# TULSA METROPOLITAN AREA PLANNING COMMISSION

For Meeting No. 2486

July 18, 2007 1:30 PM

#### PRELIMINARY SUBDIVISION PLAT

Site Topography and Utilities Plan

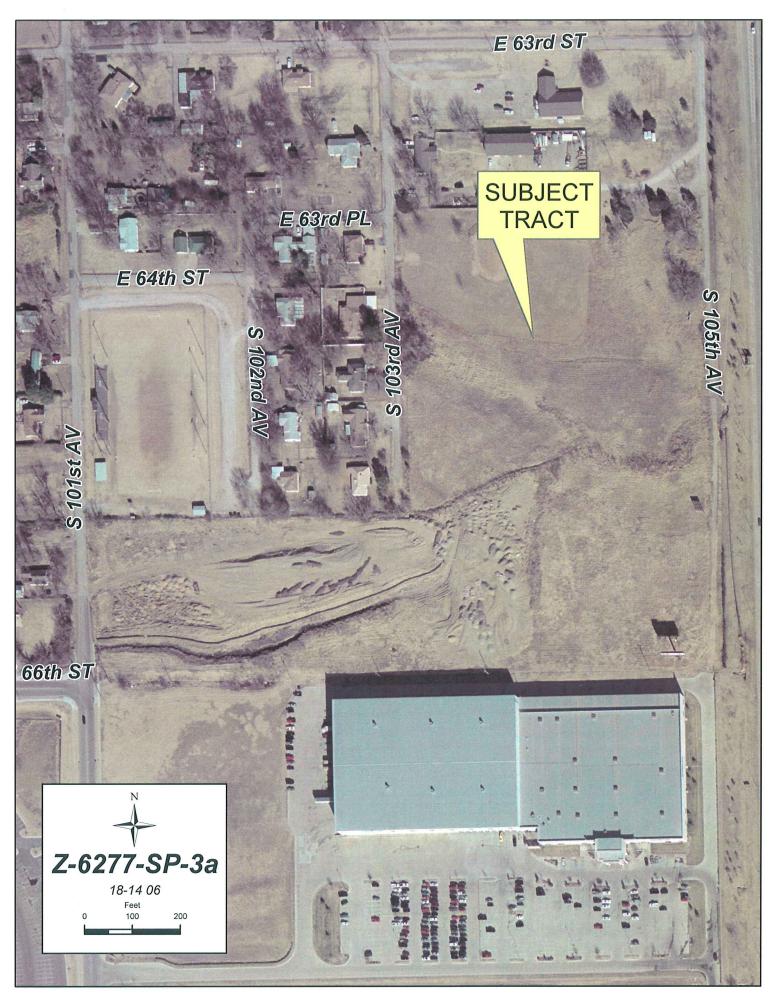
# TAC Comments for PUD 740 as revised and reviewed 7/5/07:

Cul-de-sacs shall have a turn-around radius of not less than thirty-eight (38) feet of paving, utilizing a rolled curb section wherever possible, and a radius of fifty (50') of right-of-way at the property line. For a cul-de-sac with a rolled curb section the turnaround radius may be measured to the back of the curb. Alternative turnarounds may be a one hundred and twenty (120') feet hammerhead or a sixty feet (60') "Y".

**Wastewater:** Sanitary Sewer service must be provided to all proposed lots.

<u>Transportation:</u> The "Private Drive" cul-de-sac should be curbed and guttered to meet City of Tulsa standards.

A stub street to the west, to provide non-arterial access for the adjacent 4.79 acre tract's future development, is not being proposed, and as stated in the May 17, 2007 TAC Comments, the PUD as proposed "... would force future street access with a cul-de-sac or loop system from S. Yale." In this regard, constructing an intersection on the east side of S. Yale for that tract's development may not be economically feasible in the future due to topography and recent upgrades to S. Yale Ave. Within the public right-of-way adjacent to that tract's frontage on S. Yale, a 194 ft. long retaining wall extends from a point just north of the westbound Creek Turnpike exit ramp to a point about 112 ft from the north property line of the 4.79 acre tract. The wall was constructed as part of the 91<sup>st</sup> and South Yale Ave. improvements to support sidewalk and roadway engineered fill and paving. It ranges in height from 4 ft at the ends to 13.5 ft at mid-section, with a 3.5 ft high handrail on top for the full length. Proper side street separation on S. Yale Ave. from the next nearest intersection (the 94th St. S. private street access to Ashton Woods on the west side of Yale) would require an east side street access centerline to be about even with the north end of the retaining wall. Considerable redesign, regrading, and reconstruction of the retaining wall system's north end would be required to accommodate what would be a right-in and right-out only access road at that location on the east side of S. Yale.

<u>Traffic:</u> Provide construction standards for the private streets per the Sub. Regulations within the PUD's Development Standards.
